Serial Number 10/747,647

Amendment

I, Brian D. Voyce, attorney for Applicants in a utility, non-provisional patent application entitled "*Multiple Reflector Concentrators and Systems*", Serial Number 10/747,647, filed December 29, 2003, hereby certifies and declares that the following documents attached hereto, have been sent by facsimile transmission to Art Unit 1753 care of telephone number 571-273-8300, as noted on the Office Action, and also have been deposited with the United States Postal Service, being addressed to the Commissioner for Patents, P. O. Box 1450, Alexandria, Virginia 22313-1450, having been affixed with proper postage for Express Mail delivery,

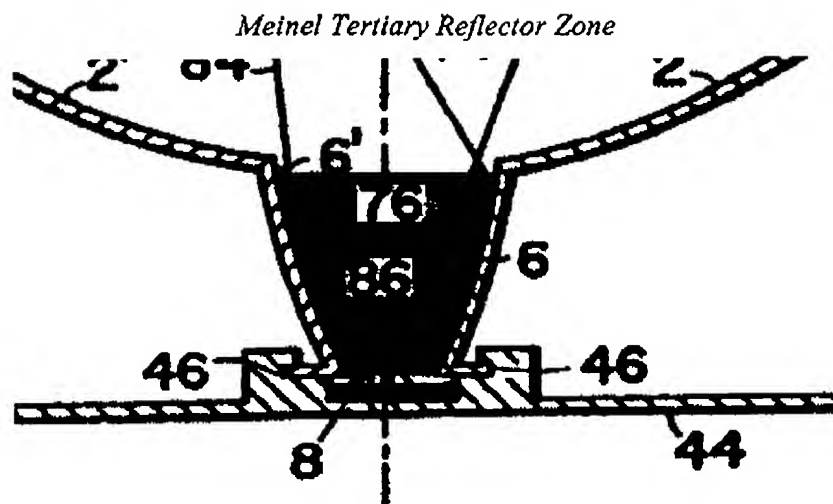
reflector is in the volume defined by that reflector (allegedly most clearly shown in Figure 4 where receiver (8) is within such a volume).

Also, Applicants cannot agree that Meinel shows or describes the receiver (8) being within the focal zone defined by the volume of the Meinel tertiary reflector. In fact, Meinel requires that the receiver (8) be placed outside the volume of the tertiary reflector. The tertiary reflector zone is illustrated by the figure below (the upper shaded portion surrounding numbers 76 and 86, shown in red). The top plane of the receiver (the lower shaded portion indicating receiver 8, shown in blue) is spaced apart from the line forming the bottom of the tertiary reflector volume. The receiver is not within that volume (shown as red). The focal zone is not within the volume of the tertiary reflector zone. Meinel would not have positioned the receiver where they did if it was not positioned at the focal zone for the tertiary reflector, an area clearly not within the volume of the tertiary reflector. Thus, Meinel can't anticipate the present invention when it requires the use of an element not found in the present invention.

tertiary reflector zone is illustrated in the above figure, as described previously. The top plane of the receiver (also in the above figure and as described previously) is spaced apart from the line forming the bottom of the tertiary reflector volume. The receiver is not within that volume. Thus, the focal zone is not within the volume of the tertiary reflector zone. Meinel would not have positioned the receiver where they did if it was not positioned at the focal zone for the tertiary reflector, an area clearly not within the volume of the tertiary reflector. Thus Meinel can't obviate the present invention when it requires the use of an element not found in the present invention.
